**EPA Superfund
Record of Decision:**

**Del Amo Facility Waste Pits OU
Los Angeles, CA
9/5/1997**

RECORD OF DECISION

Del Amo Waste Pits Operable Unit
Del Amo Facility Proposed Superfund Site

FIGURE 3
EXTENT OF CAP (APPROXIMATE)

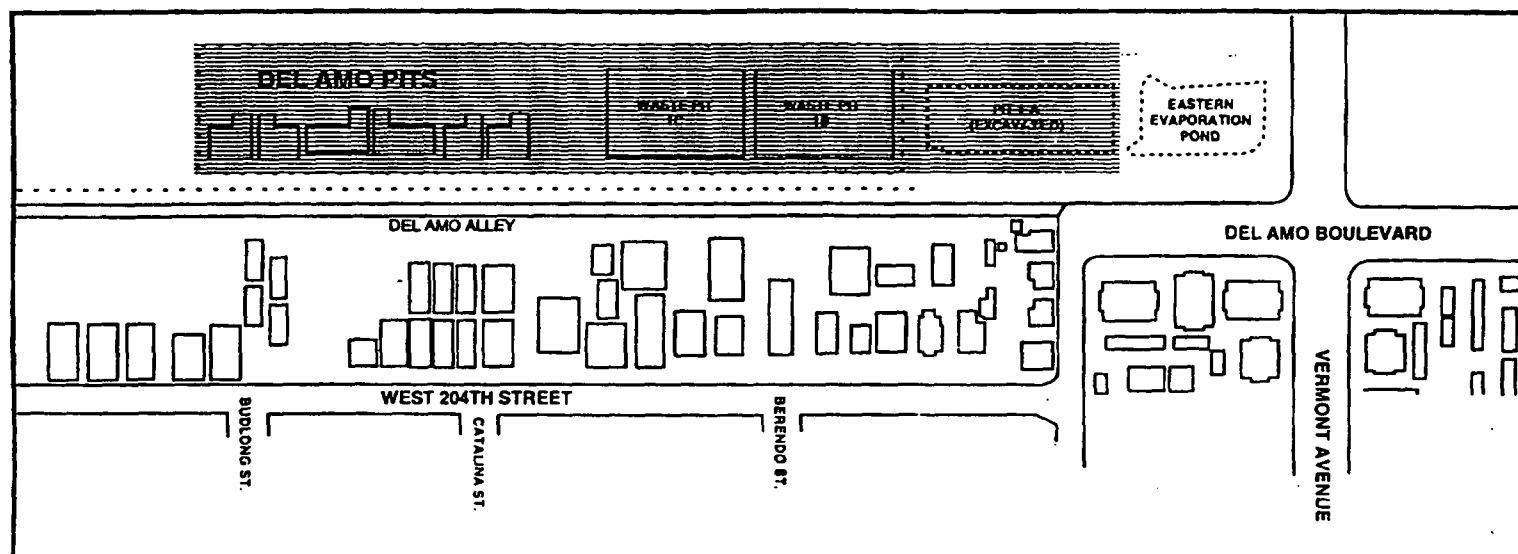
The final change is that this ROD does not provide for subsequent investigations to determine whether Pit 1A and adjacent areas should be covered by the RCRA-equivalent cap. The Proposed Plan stated that additional soil samples may be taken during design to determine the appropriateness of extending the selected clean-up plan to Pit 1A. However, the 1984 DHS report stated that contamination existed below the floor of the 1983-84 excavation. Although there was no quality assurance provided for these findings, this data is consistent with later data, taken beneath the other waste pits, that found contamination extending all the way to the water table. Because remaining contaminated soil still exists and such contamination could negatively impact the groundwater, EPA has decided, based on further review of available information, that Pit 1-A and adjacent soil as shown in Figure 3 should be covered with a RCRA-equivalent cap.

FIGURE 7.4.1-1

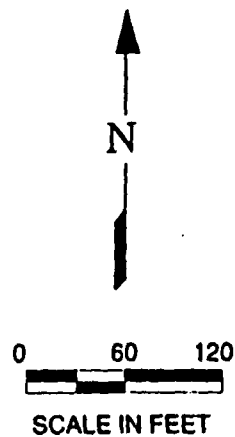
4. (Figure 7.4.1-1) - In order to maintain consistency with Section 8, we suggest this figure include the following note: "The number and location of SVE wells may change pending the selected performance standard and/or if SVE is used to target different areas of the vadose zone soils."
5. (Page 8-3 Sections 8.3 and 8.4) - It is suggested that the Costs of SVE Design Scenarios include soil gas monitoring probes, at varying depths around the perimeter of the pits, for containment and prevention of lateral soil gas migration.

Note: The number and location of SVE wells may change pending the selected performance standard and/or if SVE is used to target different areas of the vadose zone soils.
